ALLEGHENY COUNTY SANITARY AUTHORITY

CONTRACT NO. 1735 G, E, H, P

ALCOSAN PARKING GARAGE

ADDENDUM NO. 1

ALLEGHENY COUNTY SANITARY AUTHORITY
WASTEWATER TREATMENT PLANT
ALCOSAN PARKING GARAGE
210-ESL-01
ELECTRICAL ONE-LINE AND RISER DIAGRAMS
Contract: 1735
CAD File Name: 210ESL01.DWG
Date: 02/10/2021
Sheet: 154 of 158

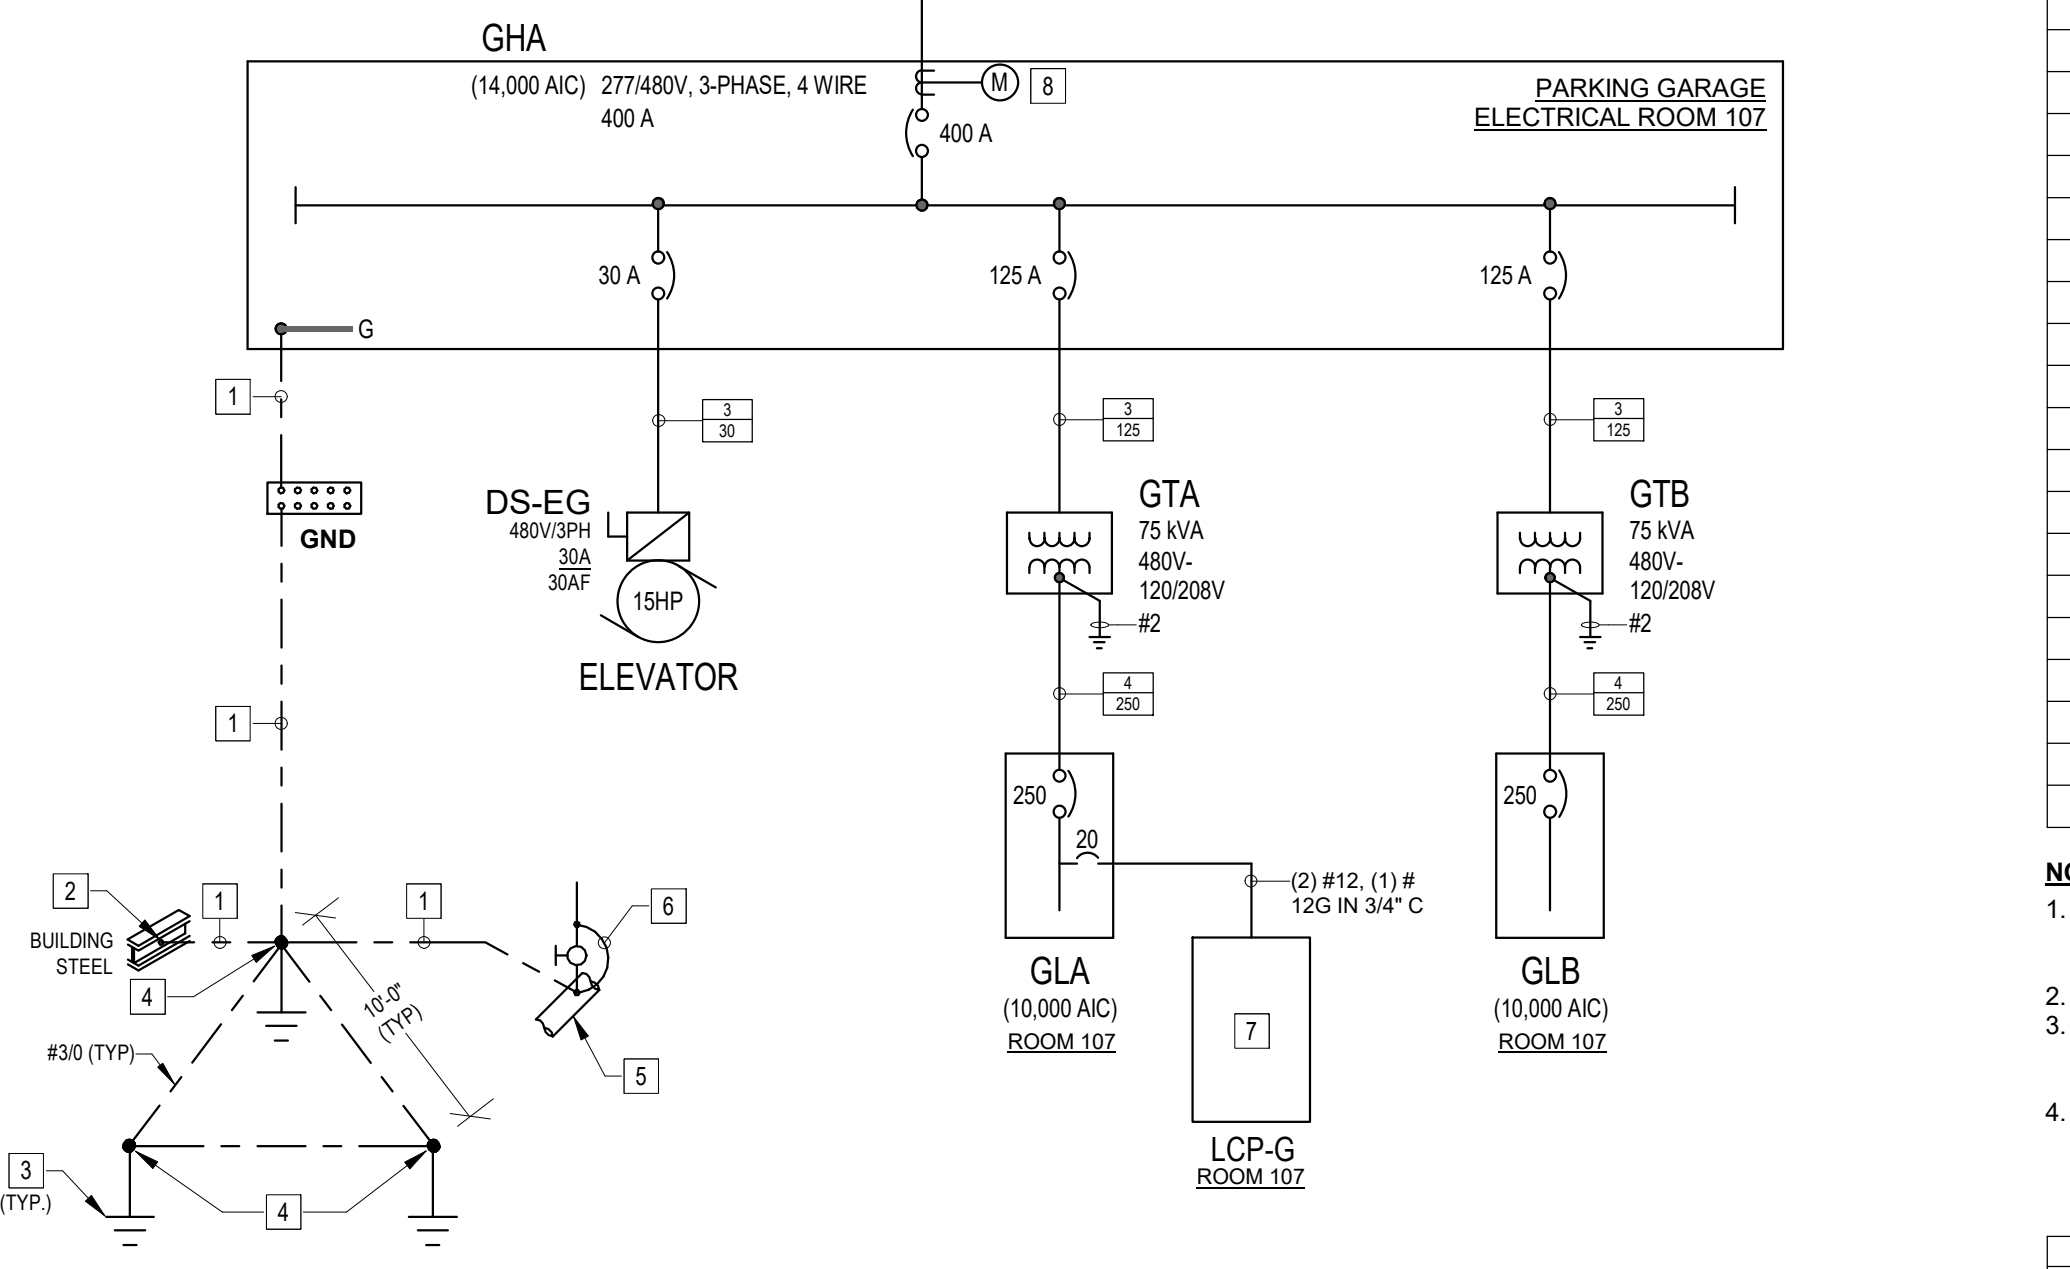
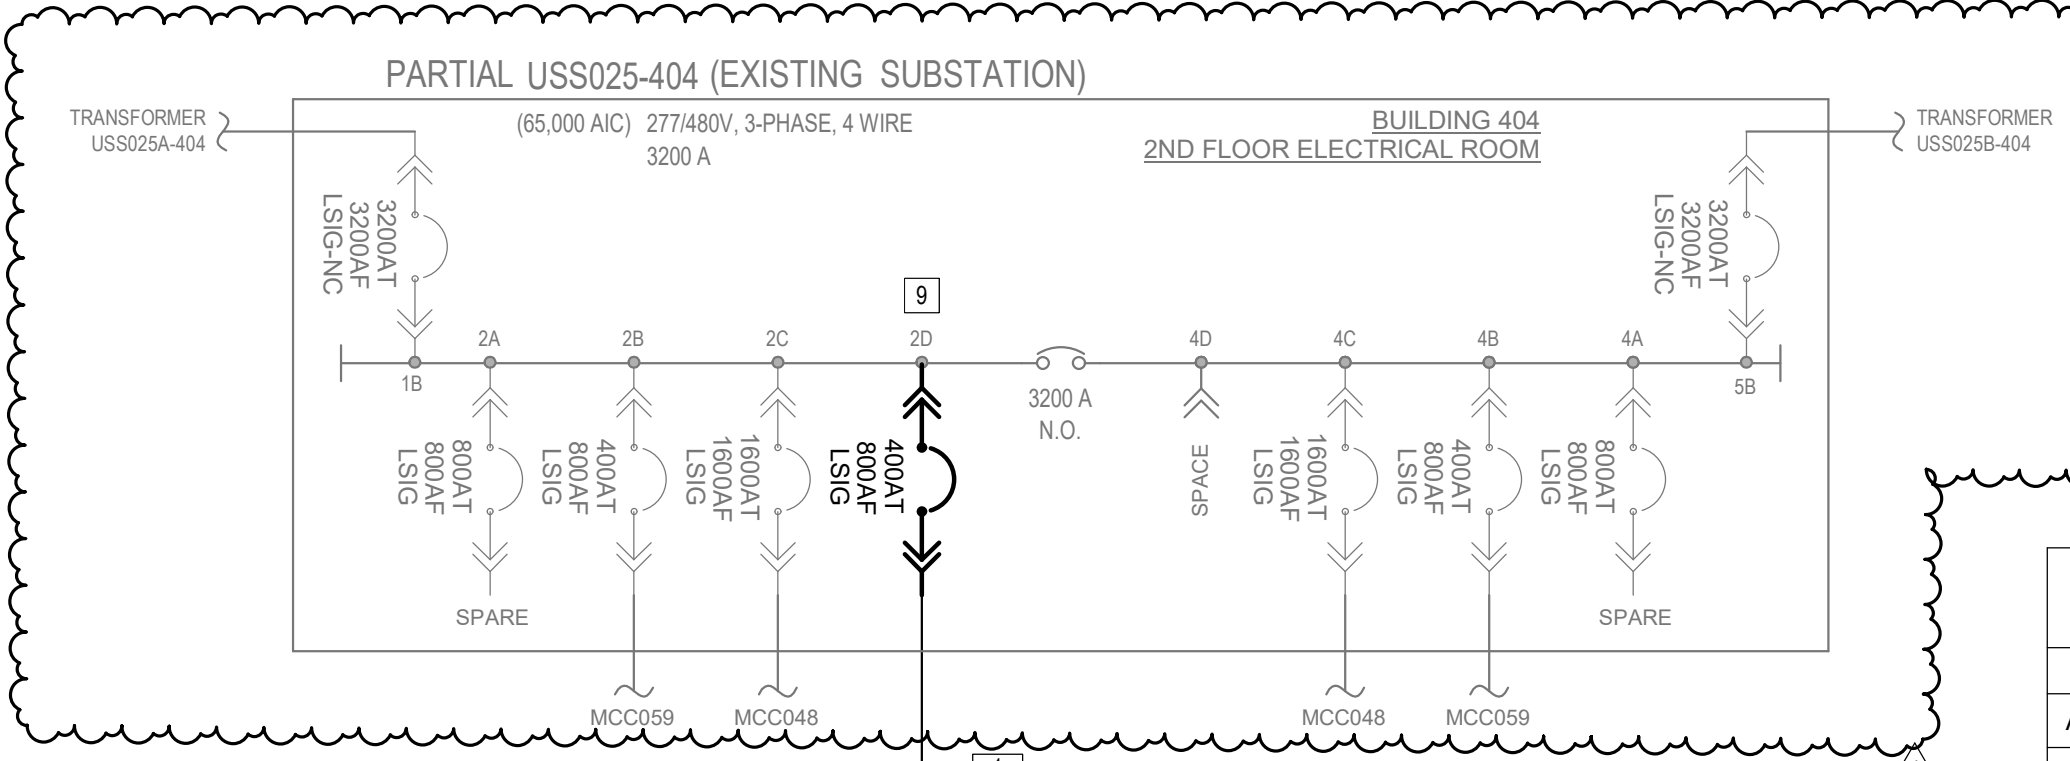
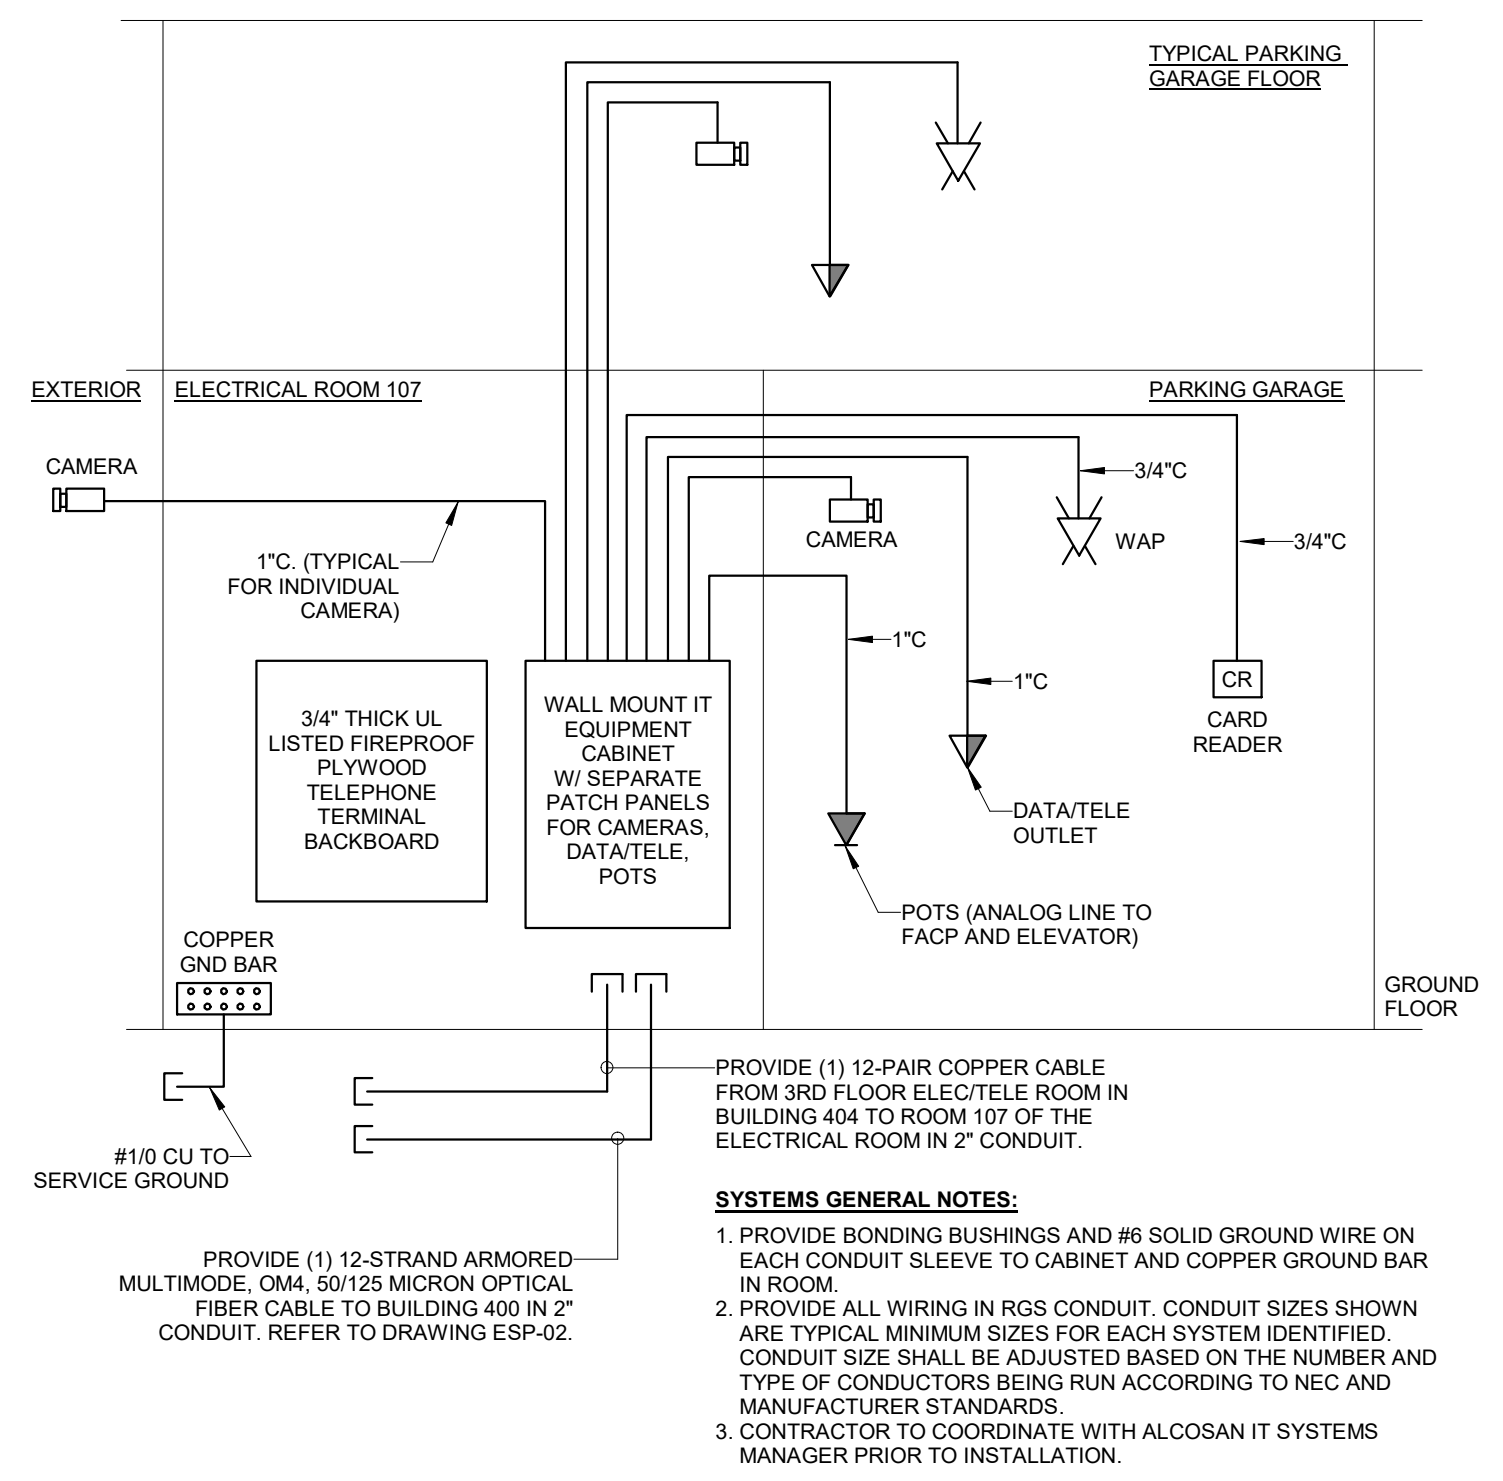
18. Drawing 210-P-01: DELETE this drawing and REPLACE with the attached drawing 210-P-01 to include the floor drain detail removal.
19. Drawing 210-ESL-01: DELETE this drawing and REPLACE with the attached revised drawing 210-ESL-01.
